Access Compliance Report

Public Rights-of-Way

Intersection ID: 15763	Main Street: MONROE_RD	Cross Street: N_WENDOVER_RD	Location: E
ADA ID: ED1A4B316845	Ramp Type: Perp	Initial Pass/Fail: Fail	Overall Compliance: No
		Severity Score: 10

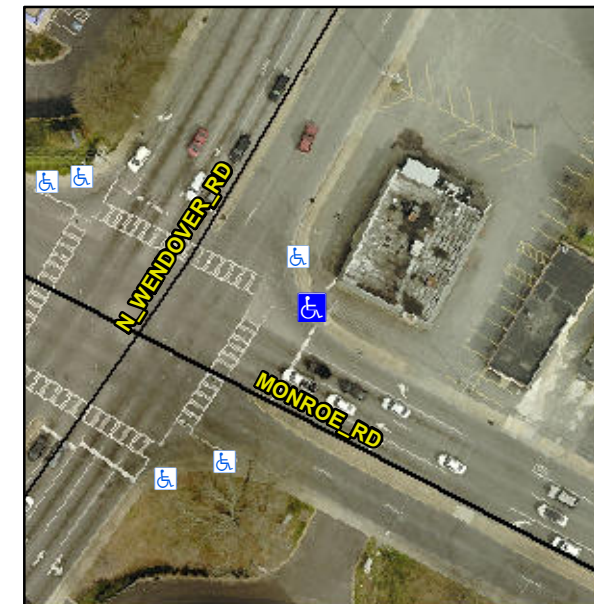
Not Found, R304.5.1, R304.5.3

Compliance	Description	Data	Compliance	Description	Data
N/A	Ramp Length (in)	59.0	Yes	Ramp Slope (%)	6.5
No	Ramp Width (in)	42.0	No	Ramp XSlope (%)	2.5
N/A	Flare Type LT	N/A	N/A	Flare Type RT	N/A
N/A	Flare Slope LT (%)	N/A	N/A	Flare Slope RT (%)	N/A
N/A	Flare Traversable LT?	N/A	N/A	Flare Traversable RT?	N/A
N/A	Landing Length (in)	N/A	N/A	DWS Provided?	N/A
N/A	Landing Width (in)	N/A	N/A	DWS Contrast?	N/A
N/A	Landing Slope (%)	N/A	N/A	DWS Length (in)	N/A
N/A	Landing X Slope (%)	N/A	N/A	DWS Full Width?	N/A
N/A	Landing Curb? (Y/N)	N/A	N/A	DWS Offset (in)	N/A
N/A	Shared Landing?	N/A			
N/A	Gutter Ponding?	N/A	N/A	Gutter Slope (%)	N/A
N/A	Gutter Lip Ht (in)	N/A	N/A	Gutter X Slope (%)	N/A
N/A	Painted X Walk1?	Yes	N/A	Painted X Walk2?	N/A
	X Walk 1 Direction	To SW		X Walk 2 Direction	N/A
N/A	X Walk 1 Width (in)	108.0	N/A	X Walk 2 Width (in)	N/A
	X Walk 1 Slope (%)	0.0		X Walk 2 Slope (%)	N/A
	X Walk 1 X Slope (%)	1.9		X Walk 2 X Slope (%)	N/A

Remove & Replace Entire Ramp.
